DATE 3 JUNE 2022

FROM ENGIE - ELECTRABEL SA

SUBJECT Observations of ENGIE- Electrabel SA to the public consultation organized by Elia on scenario, sensitivities and data for the CRM parameter calculation for the Y-4 Auction with DP 27-28

Figure 1 - Actual winter unavailabilities of the French nuclear fleet vs declared the previous March - data from RTE¹

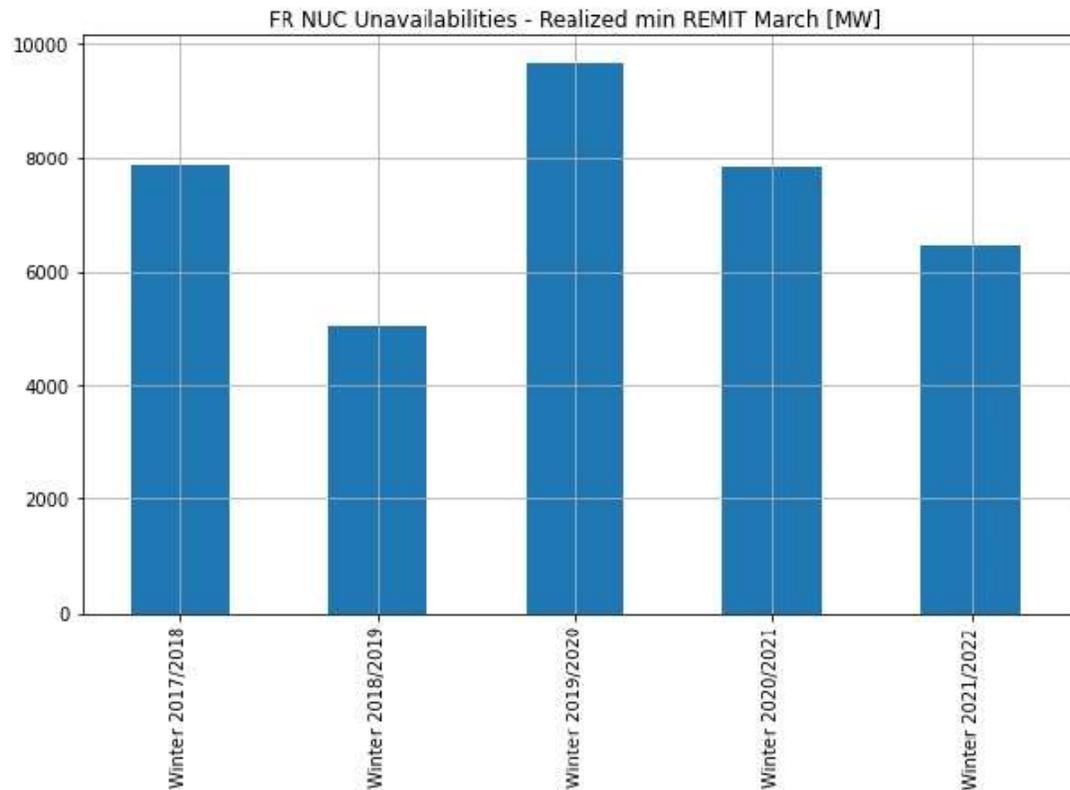
- **Lower availability of the French nuclear availability based on historical values:** according to ENGIE, based on the past performance of the French nuclear units and recent issues encountered by the French nuclear parc, **at least 8 units should be considered unavailable on average during a winter (on top of planned maintenances announced).**

The below graph shows that these unavailabilities are assessed on the basis of published shutdown forecasts for each nuclear unit. These unit-by-unit forecasts are always optimistic, with a lot of drift and almost never a shortening (except for work delays).

What is shown for the past on the figure above is very likely to be repeated in the future: **the guaranteed nuclear capacity, for every delivery year of the French capacity market, has always been lower than initially forecasted by EDF, with very low numbers expected in the next few years.** EDF's reactors have historically produced more than 400 TWh per year, but the recent very low targets suggest a low availability for the coming years. In addition, we have observed, in the last months, announcements for the unavailability of plants during the same year or year to come (cf. press release 7/2/22: “EDF ajuste son estimation de production nucléaire en France pour 2022” and press release 11/02/22: “EDF ajuste son estimation de production nucléaire en France pour 2023”). Indeed, the recent issues faced by the nuclear parc in France linked to the corrosion checks on the nuclear reactors have a big impact on their future availability (at least in the short term but with no certainty for the medium term): currently there is 12 reactors stopped due to the abnormal corrosion phenomena, which affect the safety injection circuits (supposed to allow the injection of boron water to cool the reactor in case of a leak). The group EDF also said recently in the press it was "adjusting its nuclear production estimate for 2022 to 280-300 TWh from the previous 295-315 TWh announced in February 2022 (which was already a reduction from 300-330 TWh). At this stage, and pending the completion of checks and repairs, the nuclear production estimate for 2023,
